**CONTHERM SCIENTIFIC LTD**

**TECHNICAL MEMORANDUM**

**PRODUCT : SERIES FIVE  
No : 0059**

**SUBJECT :** Replacing ZP19 PCB with ZP20 PCB

**CIRCUIT LAYOUT**

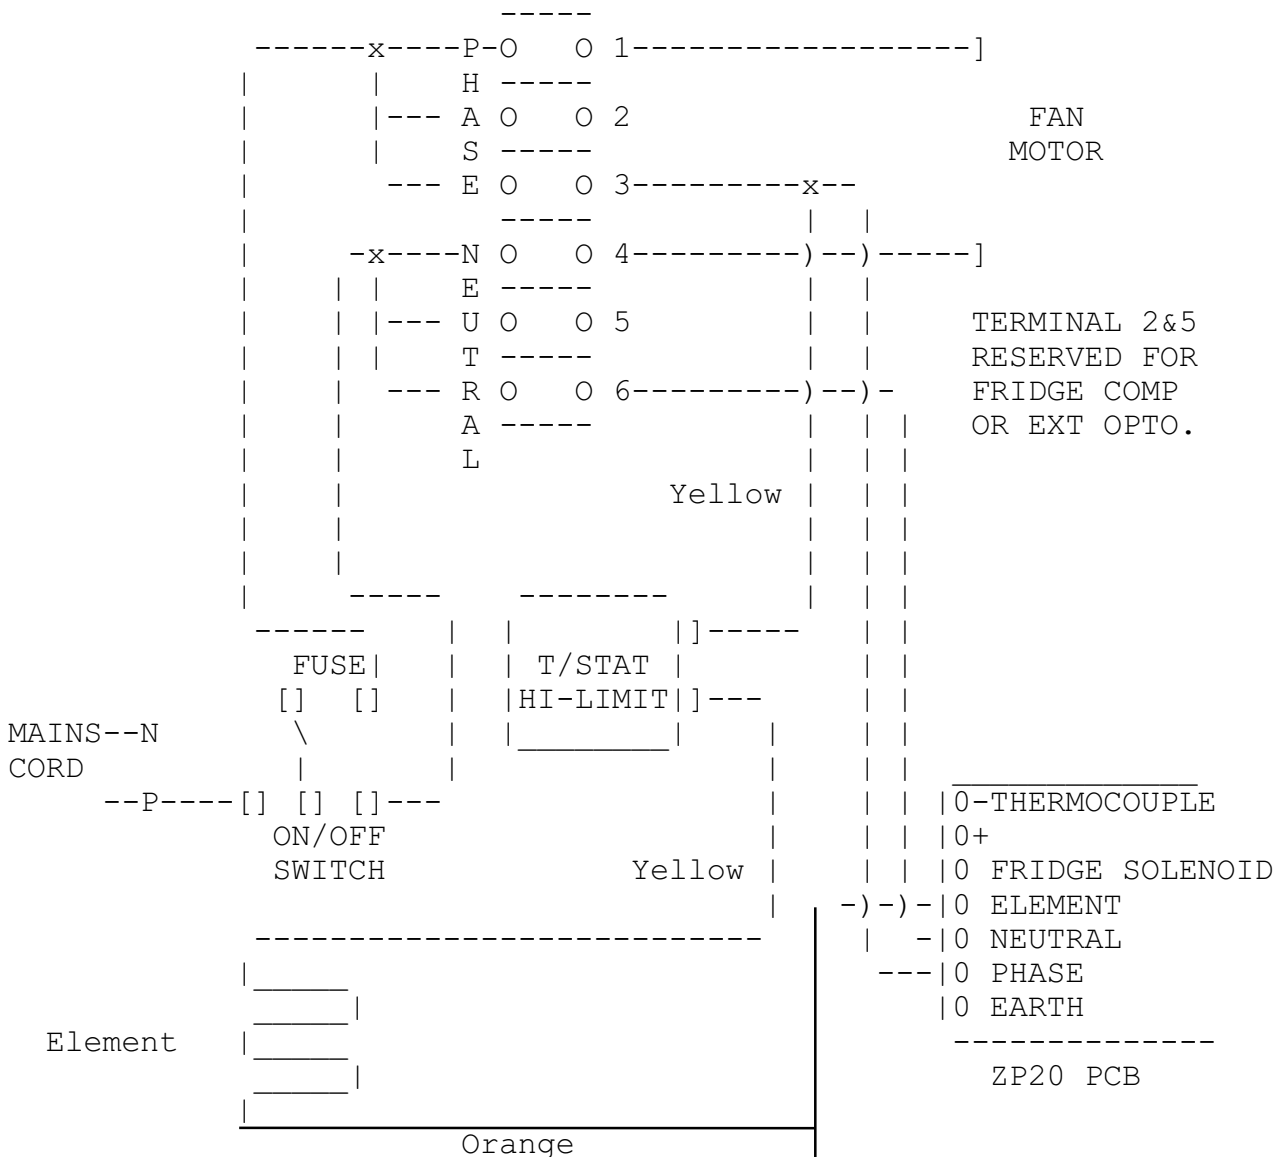
**CAUTION!:** The MAIN connector for the ZP20 PCB is **TOTALLY** different from that of the ZP19. NOTE ESPECIALLY that the MAINS connections are DIFFERENT, ensure that any PHASE, NEUTRAL and EARTH connections are made correctly. All EARTHs from the MOTOR, FRIDGE Compressor etc MUST be taken DIRECTLY to the chassis earth points and NOT to PCB connectors.

- D) Place ZP20 PCB in control panel and secure with original nuts and washers.
- E) REMOVE PHASE wire from ZP19 connector and connect to PHASE side of terminal strip. (Shares terminal on PHASE LOOPED side of terminal strip).

- F) REMOVE NEUTRAL wire from ZP19 connector and connect to NEUTRAL side of terminal strip. (Shares terminal on NEUTRAL LOOPED side of terminal strip).

- G) REMOVE EARTH from ZP19 connector and connect to EARTH on ZP20 connector.
- H) REMOVE YELLOW element wire from ZP19 connector and connect to No3 on terminal strip (PHASE side). (Shares with supplied RED wire going to ZP20 PHASE).

- I) Connect BLACK wire going from terminal strip No6 to NEUTRAL of ZP20 PCB. (See section 0059b if 250M or 260M oven).
- J) REMOVE ORANGE element wire from ZP19 connector and connect to 'ELEMENT' on ZP20 connector. (See section 0059b if 250M or 260M oven).

- K) REMOVE MOTOR PHASE wire from ZP19 connector and connect to No1 on terminal strip (PHASE side).
- L) REMOVE MOTOR NEUTRAL from ZP19 connector and connect to No4 on terminal strip (NEUTRAL side).
